# Access Compliance Report

## Public Rights-of-Way (Curb Ramps)

Intersection ID: 10033279	Main Street: OAKDALE_RD	Cross Street: N/A	Location: W
ADA ID: F4B36824F286	Ramp Type: Perp	Initial Pass/Fail: Fail	Overall Compliance: No
		Severity Score: 25

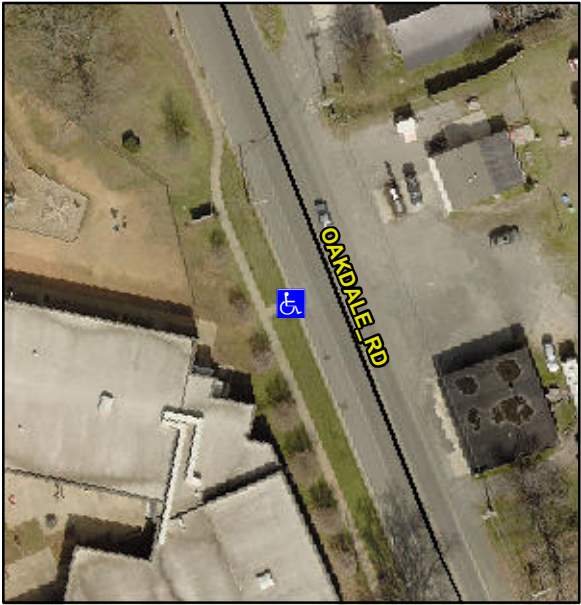
Codes/Mitigation Info/Possible Solution			Field Measurements/Component Compliance		
	Possible Solutions:		<b>Compliance</b>	<b>Description</b>	<b>Data</b>
	<b>Remove &amp; Replace Entire Ramp.</b>		<b>No</b>	Ramp Length (in)	<b>161.0</b>
			<b>Yes</b>	Ramp Width (in)	<b>61.0</b>
			<b>N/A</b>	Flare Type LT	<b>N/A</b>
			<b>N/A</b>	Flare Slope LT (%)	<b>N/A</b>
			<b>N/A</b>	Flare Traversable LT?	<b>N/A</b>
			<b>N/A</b>	Landing Length (in)	<b>N/A</b>
			<b>N/A</b>	Landing Width (in)	<b>N/A</b>
			<b>N/A</b>	Landing Slope (%)	<b>N/A</b>
			<b>N/A</b>	Landing X Slope (%)	<b>N/A</b>
<p>Surveyor Notes:</p> <p><b>N/A</b></p> <p>PROW/ADA:</p> <p><b>R304.2.2</b></p>			<b>N/A</b>	Flare Type RT	<b>N/A</b>
			<b>N/A</b>	Flare Slope RT (%)	<b>N/A</b>
			<b>N/A</b>	Flare Traversable RT?	<b>N/A</b>
			<b>N/A</b>	DWS Provided?	<b>N/A</b>
			<b>N/A</b>	DWS Contrast?	<b>N/A</b>
			<b>N/A</b>	DWS Length (in)	<b>N/A</b>
			<b>N/A</b>	DWS Full Width?	<b>N/A</b>

<b>N/A</b>	DWS Offset (in)	<b>N/A</b>
			<b>N/A</b>	Shared Landing?	<b>N/A</b>
			<b>N/A</b>	Gutter Ponding?	<b>N/A</b>
			<b>N/A</b>	Gutter Lip Ht (in)	<b>N/A</b>
			<b>N/A</b>	Painted X Walk1?	<b>Yes</b>
				X Walk 1 Direction	<b>To E</b>
			<b>N/A</b>	X Walk 1 Width (in)	<b>125.0</b>
				X Walk 1 Slope (%)	<b>0.7</b>
				X Walk 1 X Slope (%)	<b>1.8</b>
			<b>N/A</b>	Ramp inside XWalk1?	<b>Yes</b>
			<b>N/A</b>	Road Slope (%)	<b>N/A</b>
			<b>N/A</b>	Road X Slope (%)	<b>N/A</b>
			<b>N/A</b>	Any Obstructions?	<b>N/A</b>
Total Cost:		<b>\$ 1850.00</b>		Obstruction Type	
			<b>N/A</b>		<b>N/A</b>
			<b>Yes</b>	Surface Condition? (G/P)	<b>Good</b>
